**PLANNING COMMISSION SITE PLAN
HILL COUNTRY ROADWAY REVIEW SHEET**

CASE NUMBER: SPC-2013-0122D **PLANNING COMM'N DATE:** 6-25-2013

PROJECT NAME: Miller Tract/ St. Andrew's School Tract driveway

CITY OF AUSTIN – PLANNING AND DEVELOPMENT REVIEW DEPARTMENT
SITE PLAN APPLICATION – MASTER COMMENT REPORT

SITE PLAN

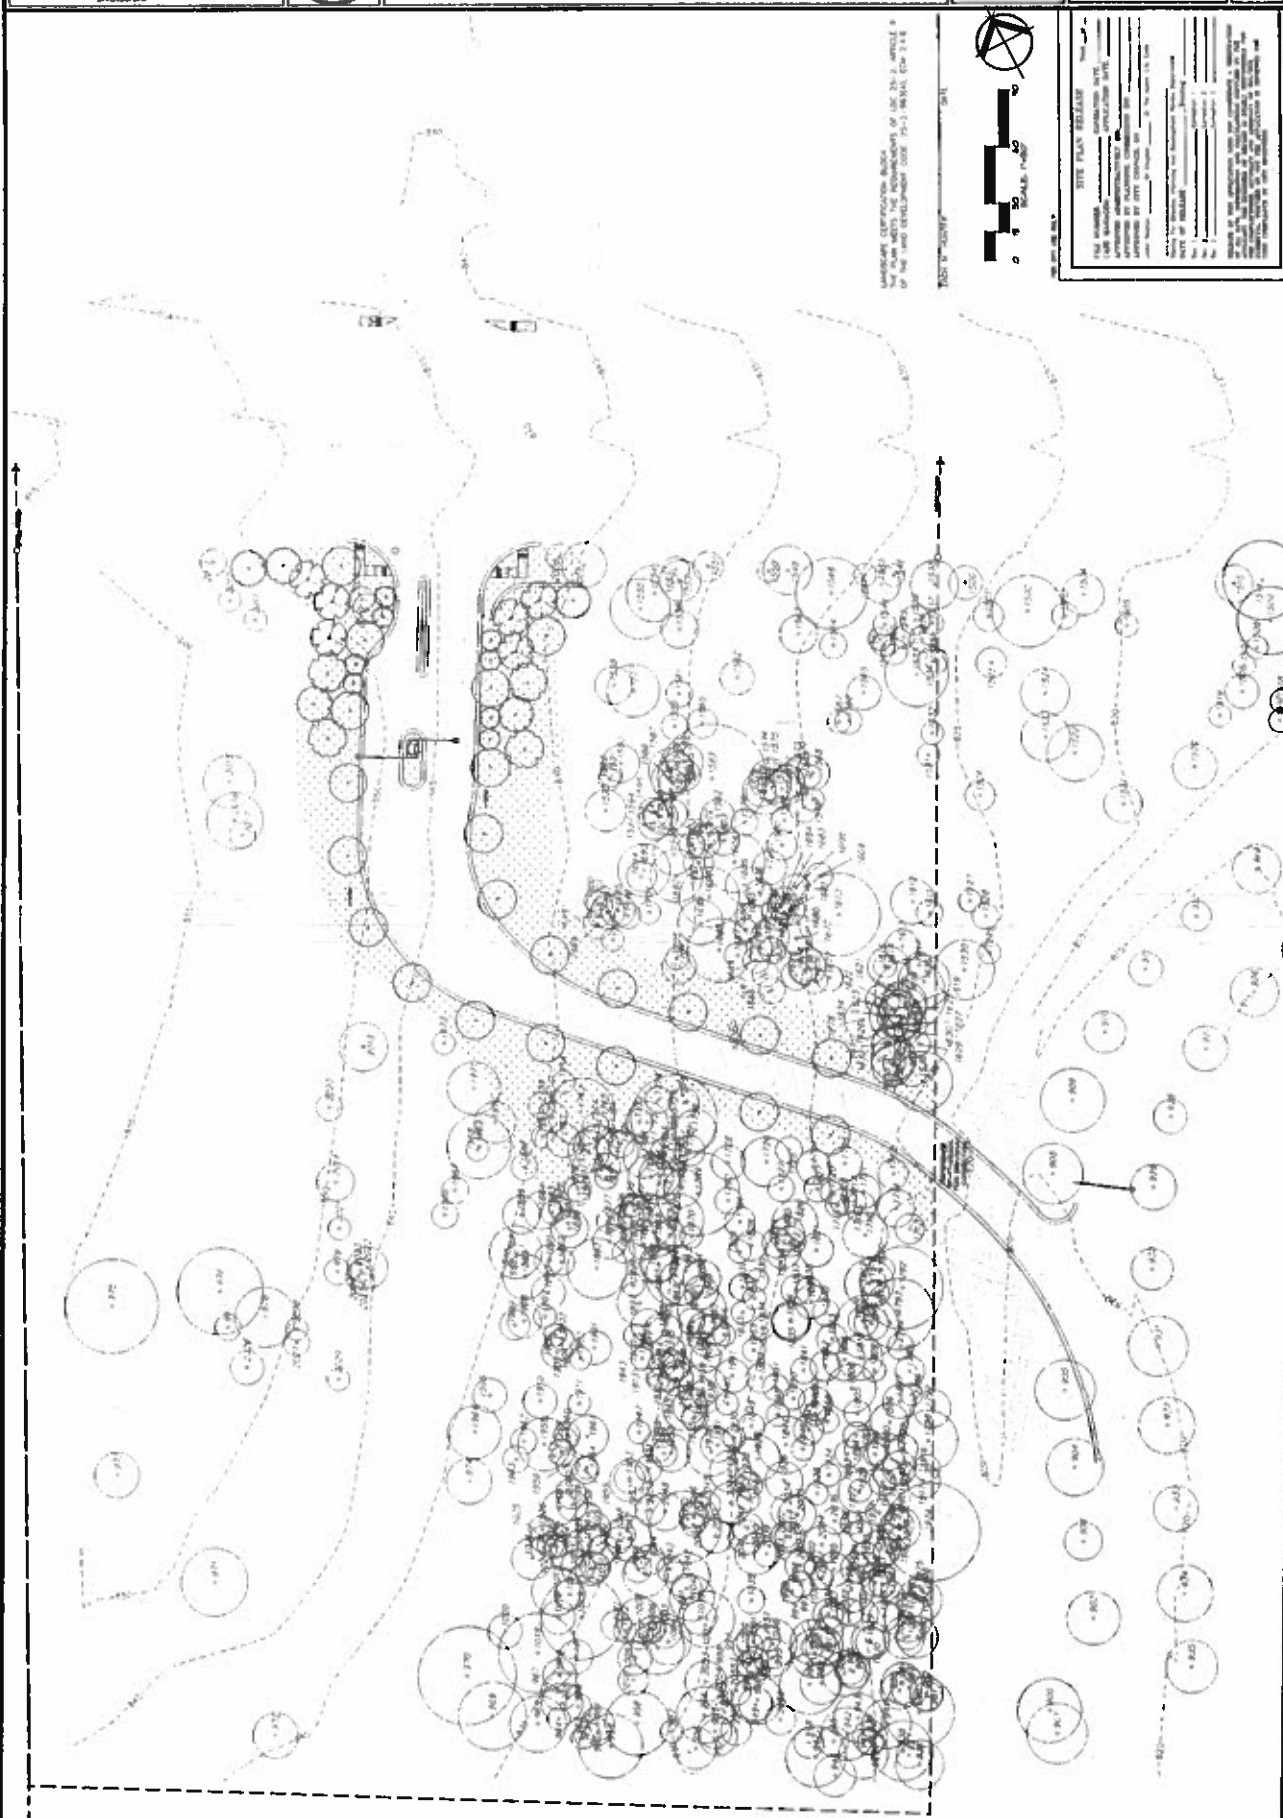
SP 2. Please show the 50' highway vegetative buffer line on the site plan.

SP 3. Hill Country Roadway Ordinance calculations need to be shown on the site plan also. Show that minimum 40% of the site is undisturbed natural area.

SP 4. This site plan is shown on the site that is adjacent to the existing school facility but does not show that site as part of this proposal. Both properties are owned by St. Andrew's School. Please show connection of the sites through this driveway by either filing a unified development agreement restrictive covenant that ties the tracts together as one site for the purposes of calculations, drainage and access, or complete this site plan as a stand-alone site and file a joint-use-access easement for the driveway and execute a site plan correction on the Harpers Park Lot 1 site (the school site) to add the driveway connection on that site.

SP 7. Call out the amount of impervious cover in square feet, and percentage in the LR-MU-NP zoning calculations.
